RE: Planning Commission Agenda Packet for December 15, 2021 Regular Meeting

- a. **SP 21-01 – Dollar General, T-20-01-395-005, Final Site Plan Review** – Dollar General is seeking final site plan approval for the construction of a 9,100 square foot retail store and associated site improvements. Our review has been updated based on the revised plan submitted since the November Planning Commission meeting. All outstanding planning issues have been addressed.
- b. **SLU 21-01 Railsplitter #2 – Special Land Use - Multiple Properties.** An application has been received for a special land use for large-scale solar project north of Arkona, south of Talladay, east of Sanford and west of Gooding encompassing thirteen (13) parcels and 478 acres of land. A pre-application conference was conducted at the April 2021 Planning Commission meeting. A public hearing was conducted at the September 2021 Planning Commission meeting.

Subject: **Site Plan Review Responses**

DOLLAR GENERAL STORE #22731
AUGUSTA, MICHIGAN
10467 WILLIS ROAD

SHEET
C1

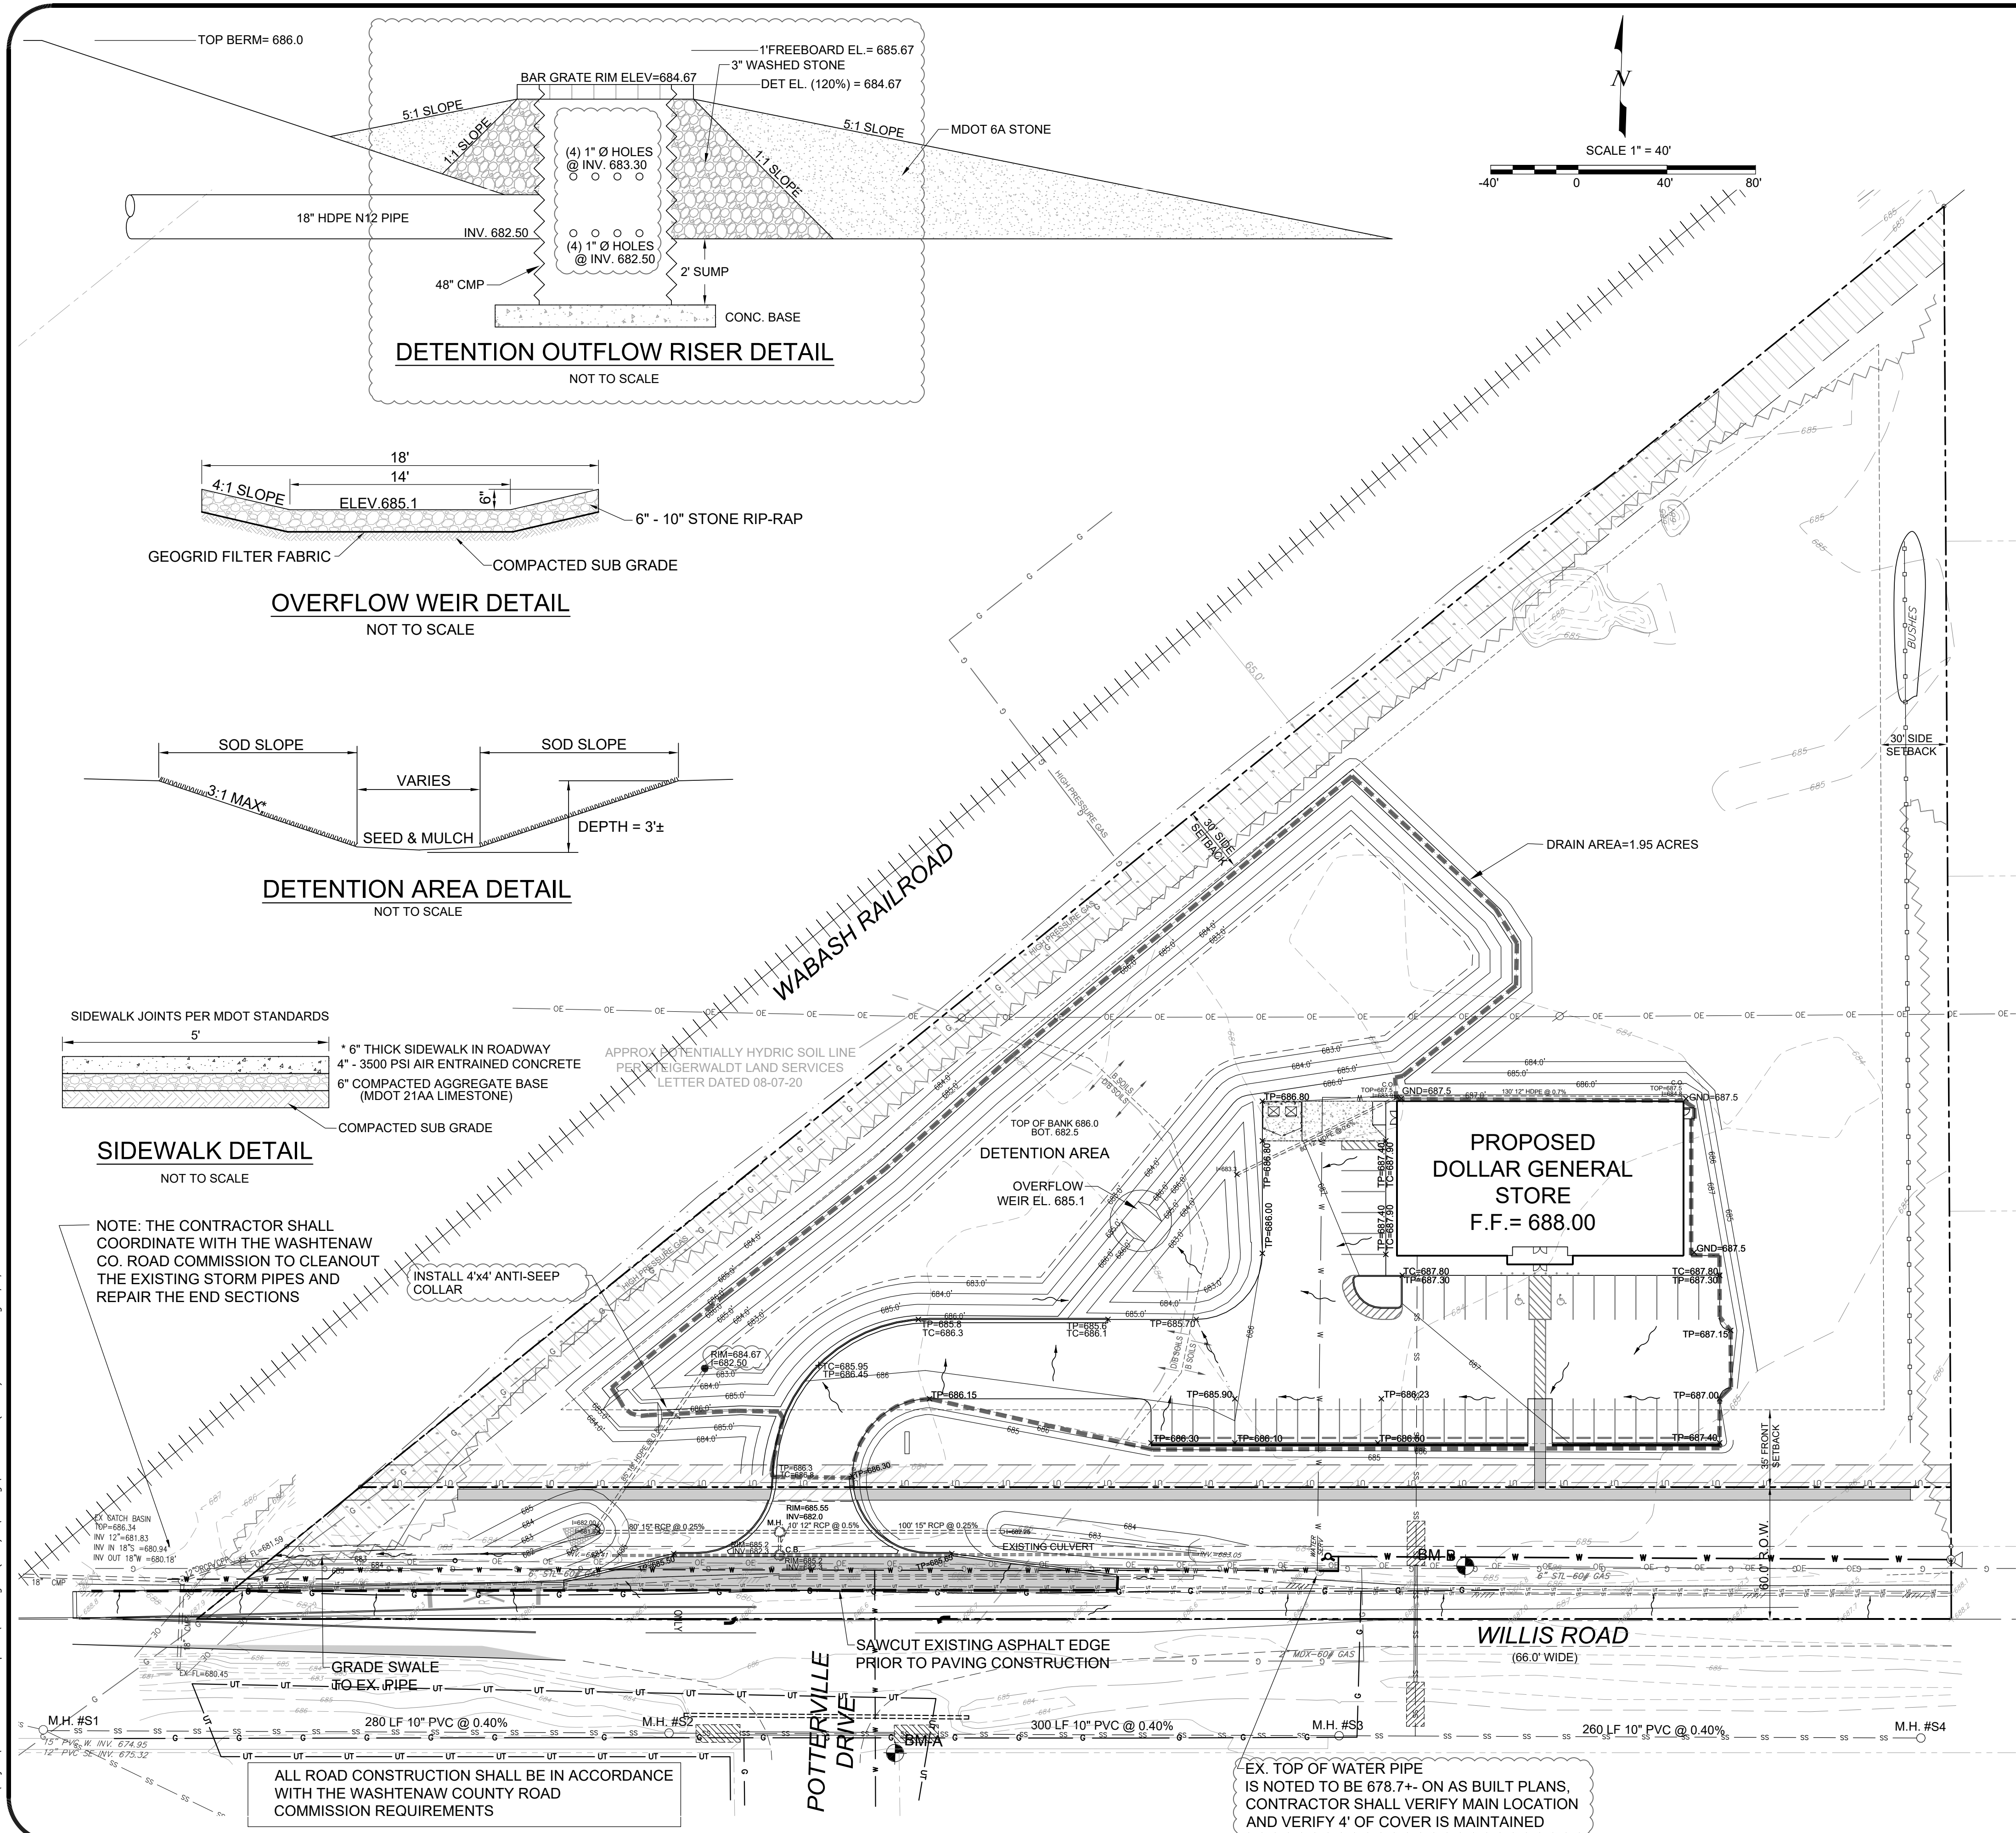
3. *The Planning Commission requested a vinyl fence along the east property line as opposed to the wood fence during preliminary site plan. Wood fencing still shown.*

Overland Engineering Response: Sheets C1, C4 and C5 have been revised to show the Vinyl fence as noted.

Overland Engineering Response: Additional fence and landscape screening has been added to Sheet C1 and C5 as noted.

VINYL PRIVACY FENCE DETAIL
REFER TO SELECTED MANUFACTURER'S DETAIL FOR INSTALL
NOT TO SCALE

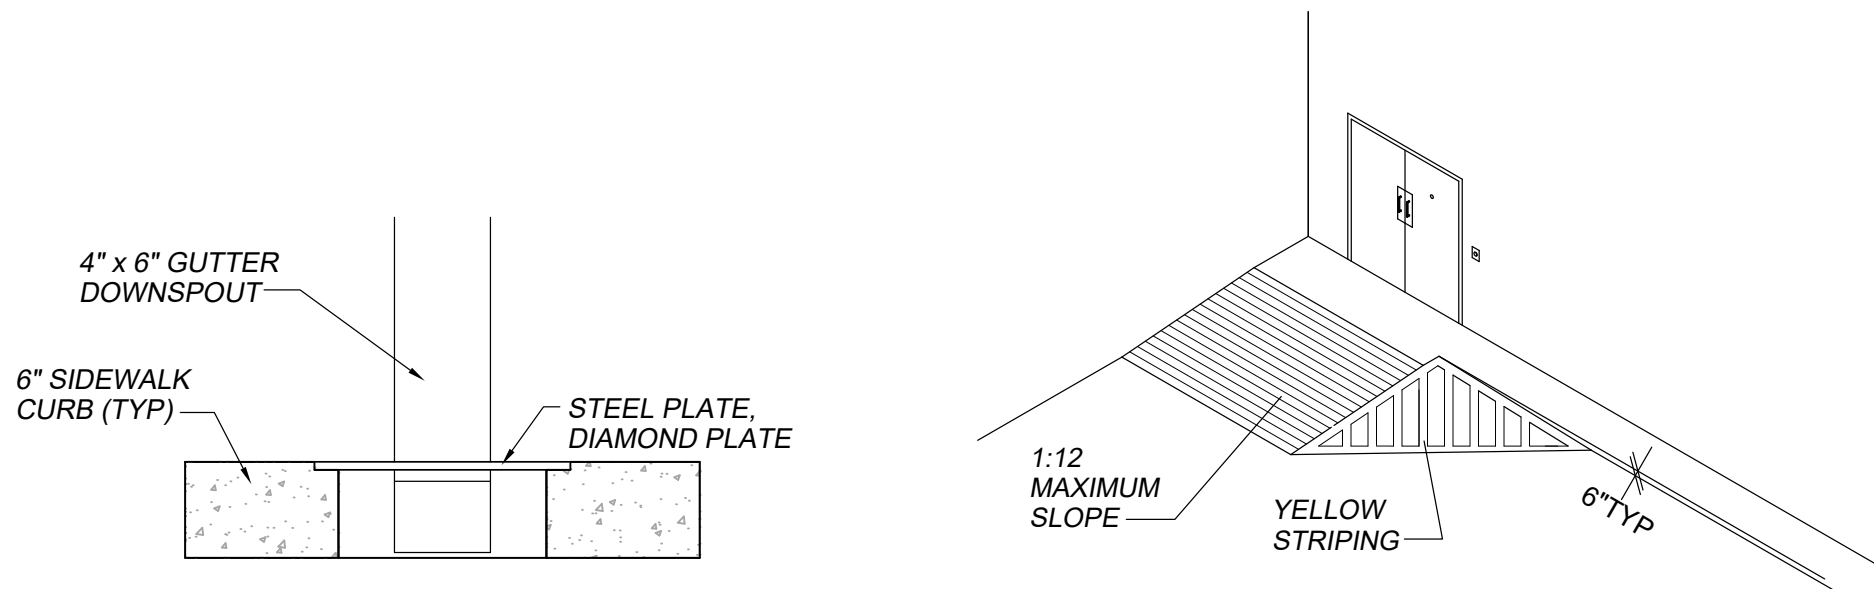
Evergreen plantings and a wooden privacy fence are provided along the entire east property line. We note a detail of the proposed 6-foot-tall privacy fencing is provided on Sheet C4.

LANDSCAPE PLAN

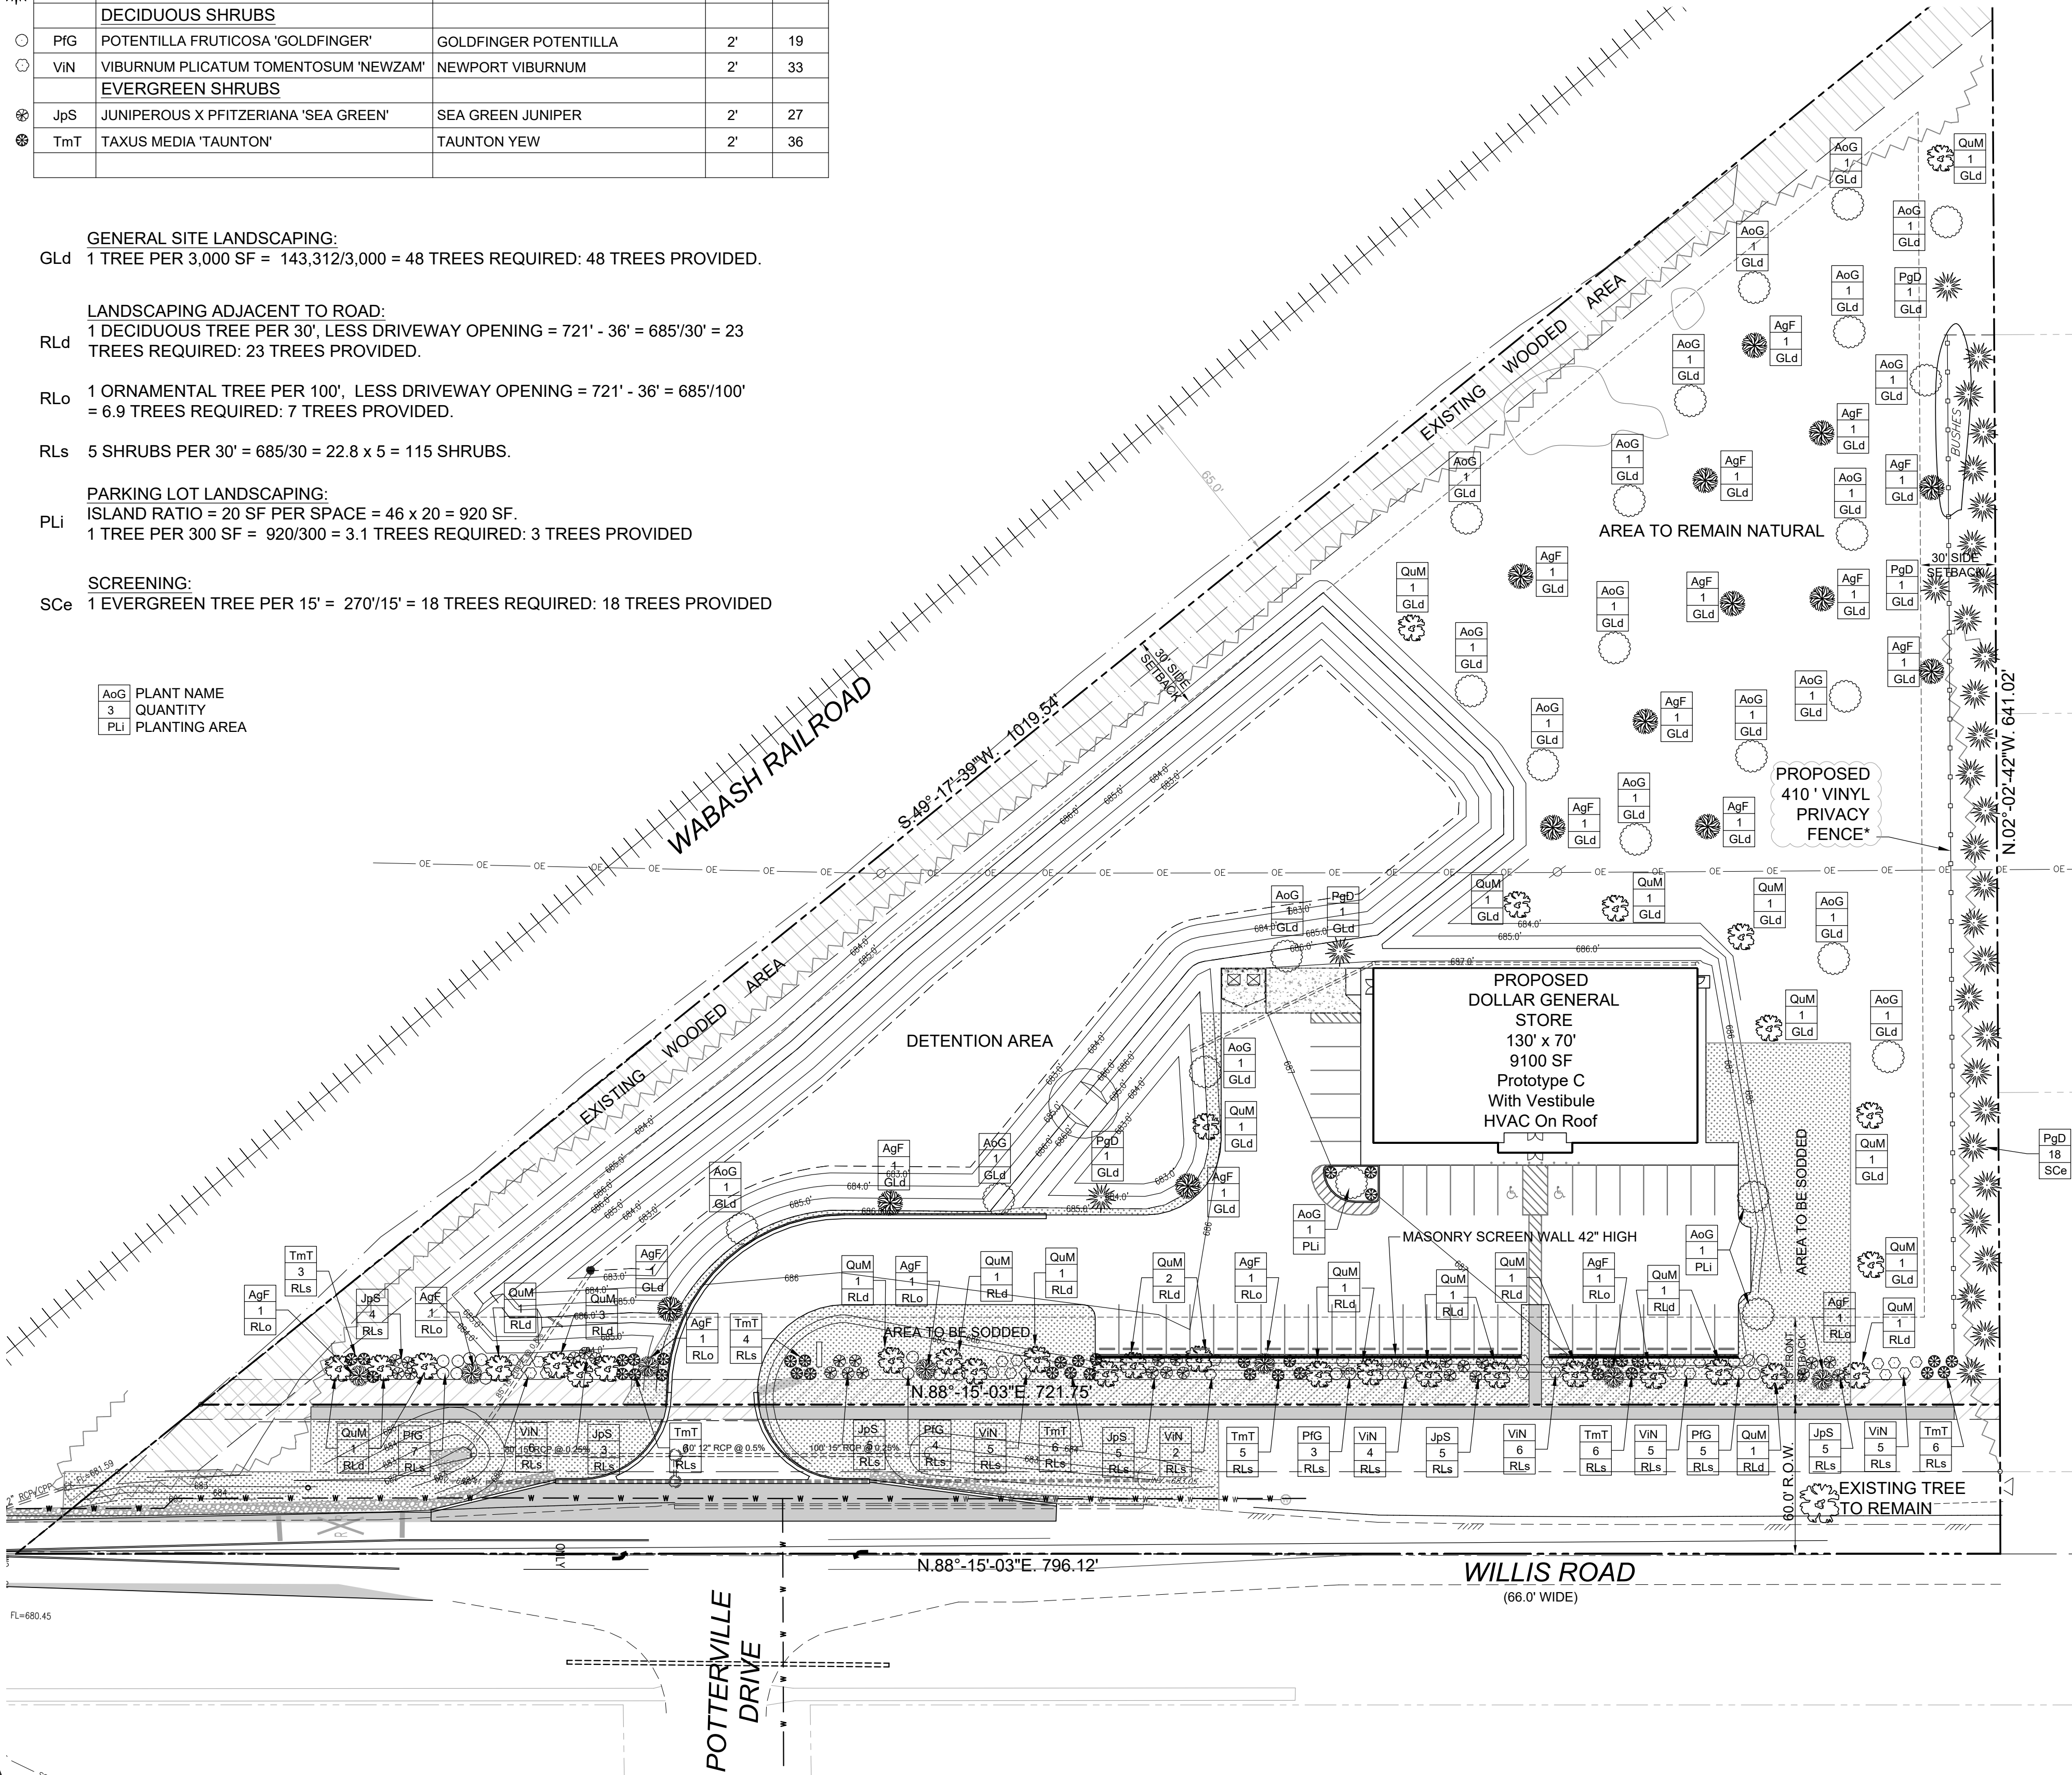
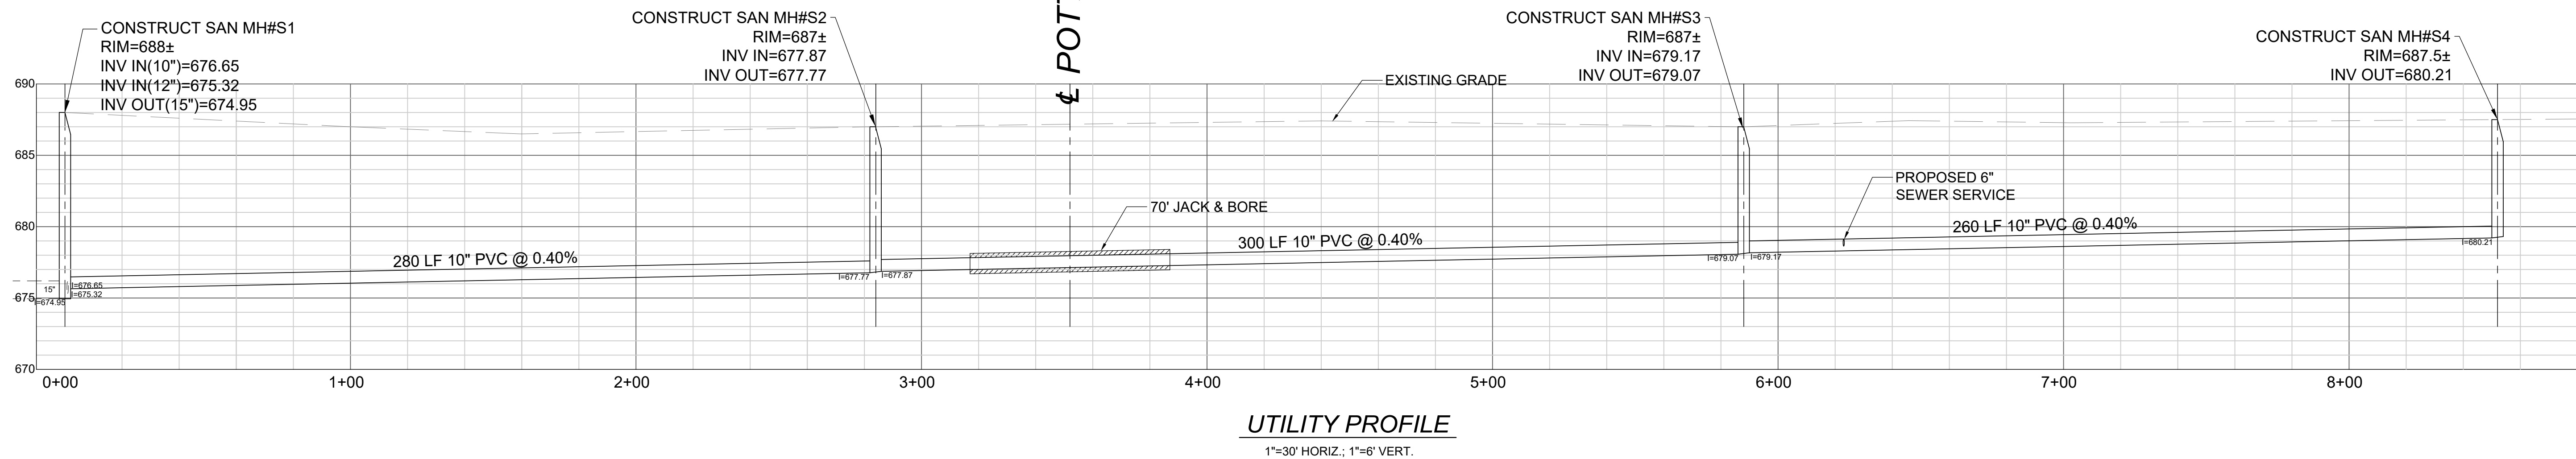
General Site Landscaping: All undeveloped portions of the site not already containing specific landscape requirements shall contain one (1) deciduous or evergreen tree per every 3,000 square feet of undeveloped area. The applicant provides on Sheet C1 that the site will maintain 3.29 acres (143,312.4 SF) of open space ($143,312.4 / 3,000 = 47.7$ trees). The applicant has provided 47 general site landscaping trees as required.

1. Provide Washtenaw County Road Commission approval.
-Gary Streight at WCRC is finalizing the permit and should be in contact soon.
2. Provide 18 additional general site landscaping trees.
-Revised as noted, see Sheet C5.
